# UNITED STATES ENVIRONMENTAL PROTECTION AGENCY

Re: Request for Information ("RFI") Pursuant to Section 308 of the Clean Water Act

Sanitary Sewer System Compliance Evaluation Inspection

**Borough of North Haledon Sanitary Sewer System**

Molly Ann Pump Station; a) Holding Tanks, b) aerators, c) barscreen, and d) some

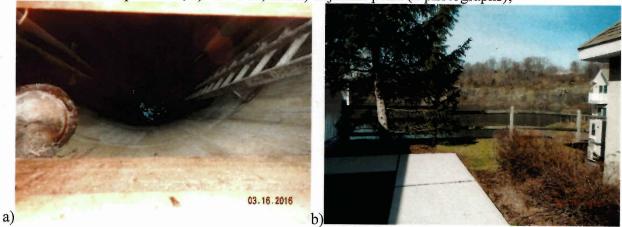
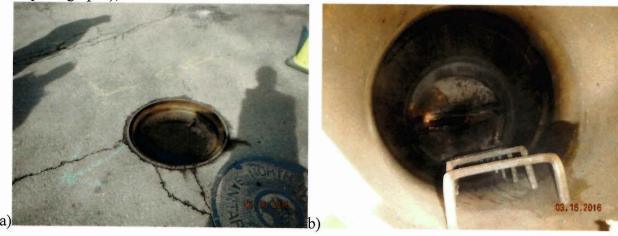
- 37. At the Molly Ann Pump Station, the Borough has four (4) 500,000 gallon holding tanks, details are provided below:
  - a. All Borough sanitary sewage goes through the Molly Ann Pump Station.

- b. According to Borough representatives, the Borough's standard procedure is to open the valve to the holding tanks to allow flow to be pumped through a "T" shaped intersection where half the flow is diverted to the holding tanks and half continues to the PVSC regulator. However, it is possible to close the valve in the direction of the PVSC regulator to completely divert all Borough sanitary sewage flows into the holding tanks.

- c. The valves used to divert the flow into the holding tanks are currently manually operated.
  - d. According to Borough representatives, the Borough has solicited quotes to automate the valve operations and received quotes at approximately \$37,000 for the valve and approximately \$14,000 for the SCADA system and other engineering.

- e. Each of the four (4) tanks can be filled and emptied individually.
  - f. According to Borough representatives, the Borough's standard procedure is to utilize primarily the first two (2), easternmost tanks where flow fills up first and then as necessary overflows into the second two (2) tanks.

- g. The tanks are equipped with aerators for odor control.
  - h. All four (4) tanks are equipped with bar screens at the drainage point.
  - i. Use of the tanks is documented in the daily log.

- k. According to Borough representatives, the Fire Department is brought in to hose down and clean the tanks after each use. However, at the time of the inspection, the tanks had not been cleaned since they were last used in February 2016.

- 1. The Borough did not have a written Standard Operating Procedure (SOP) for the use and maintenance of these valves and holding tanks, at the time of the inspection.

- a. North Haledon should develop and implement a wet weather operating procedure where the holding tanks are utilized during wet weather events to store the Borough's sanitary sewage flow until after the wet weather event has ceased. Given that the Borough's sanitary sewage enters the PVSC regulator structure immediately upstream from the City of Paterson Short Street Combined Sewer Overflow (CSO) Outfall (022), utilizing the tanks for storage during wet weather would ensure that Borough sanitary sewage flow is treated at PVSC's WWTP and does not discharge out the CSO Outfall. The Borough has the ability with existing infrastructure to store all sanitary sewage flows from the Borough for up to two (2) days in the holding tanks (at an estimated one (1) MGD of flow in the two (2) MG capacity holding tanks).
